## THE COUNTY OF GALVESTON

**PROJECT NAME:** Willow Bayou/Avenue L Drainage  
**SOLICITATION NOS:** ITB #B211024  
**RE:** ADDENDUM #1

**Reference:** Plan Set  
**Replace:** Sheets 2, 8, 10, 11, & 13 in the Plan set with the sheets marked ADDENDUM NO. 1

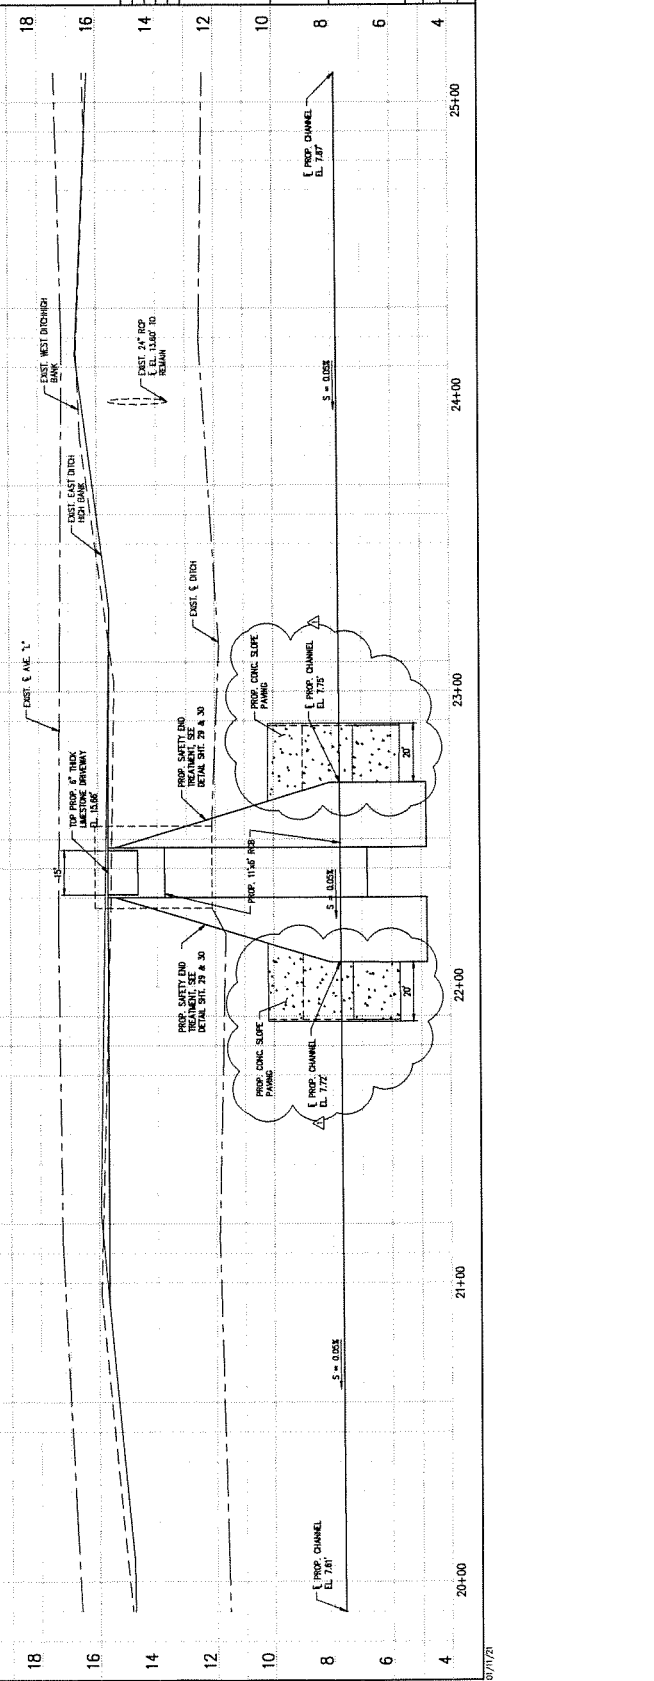
- Reference:** Question– Regarding plan sheet 10 of 33, at station 22+38.61 (111' Right), a proposed Hoover gate is called out. There does not appear to be a bid item for this gate. Is a new gate required here, or is a previously installed gate being relocated to this location as indicated in bid item number 21?

**Answer:** A bid item was added for the gate.
- Reference:** Question– There are manholes shown on the plans on 8, 10, and 11, however, there does not appear to be a bid item for these manholes. Under what bid item are these manholes intended to be paid?
